RE: DSP-19031-02 Popeyes

Application Number: DSP-19031-02 (TCP-026-2018-02)(AC-24001)

Application Name: Three Roads Corner Popeyes Restaurant

Re: Notification of Planning Board Action on **Detailed Site Plan DSP-19031-02 Popeyes**

Figure 2: Detailed Site Plan

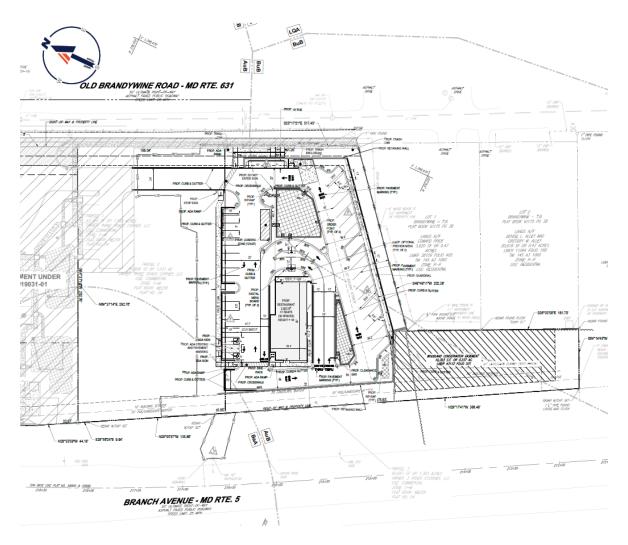
Design Features: The site contains four parcels, which share a vehicular entry/exit point located on MD 631, specifically on Parcel 1. Parcels 1 and 4, approved with DSP-19031, will be developed with a 7-Eleven convenience store, a gas station, and a car wash. Through the subject DSP, Parcel 3 will be developed with a 2,923-square-foot eating and drinking establishment with drive-through service. Parcel 2 is currently vacant.

The subject development is oriented towards MD 5 and has pedestrian access from MD 631. The building is one-story and is approximately 19 feet in height. Two drive-through lanes are located to the south of the building, with two separate menu display boards, and then merge into one lane before the pick-up window.

Figure 3: Proposed West (upper) and North (lower) Elevations

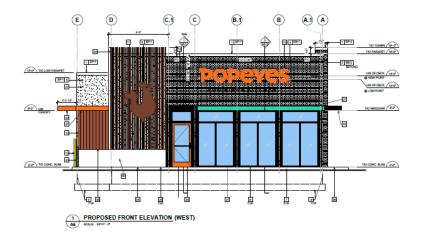
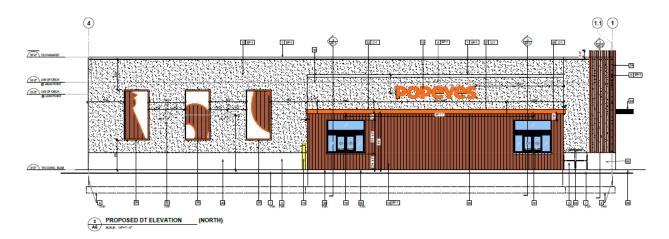
The architectural design of the proposed building is contemporary with a flat roof. The building is finished with a mix of materials, including brick veneer, stucco finished exterior insulation and finish systems, glass, aluminum tubes, and pre-finished metal cap. The materials are arranged in a geometric pattern.
